Lake Hume Battery Energy Storage System
Application No: SSD-10460

Whilst I am supportive of renewable energy I have concerns with the design and location of the proposed development and I make this submission in objection to the application.

Figure 12-1: Project location and nearby receivers

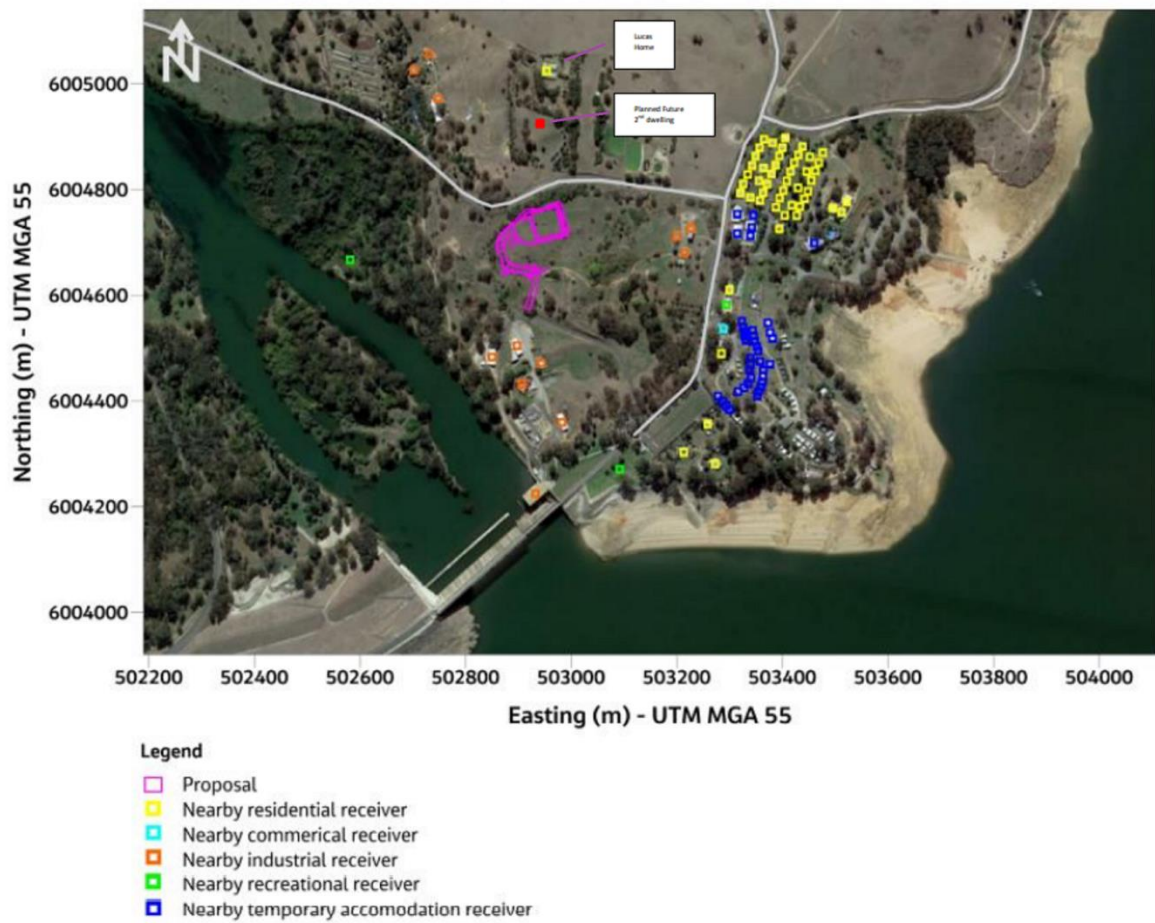
I am the joint owner and resident of the property known as “Lanark” which is situated at 32 Trout Farm Road, Lake Hume Village. The property and home (RR01) is described in the EIS as “the closest receiver” to the BESS. The land, and property entrance, is directly adjacent to the proposed “Northern location” of the Meridian Hume BESS.

- (v) Socio economic – amenity audio- 12 dB(A) above the NML and rated **moderately intrusive**, 30 dB(A) above the NML at our mailbox.
- (vi) Community safety - for the personal safety of users of the Trout Farm Road passing the BESS (vehicle and cyclists); and for ourselves or our visitors if we were outdoors; were a major incident to occur (ie not “normal operation”).
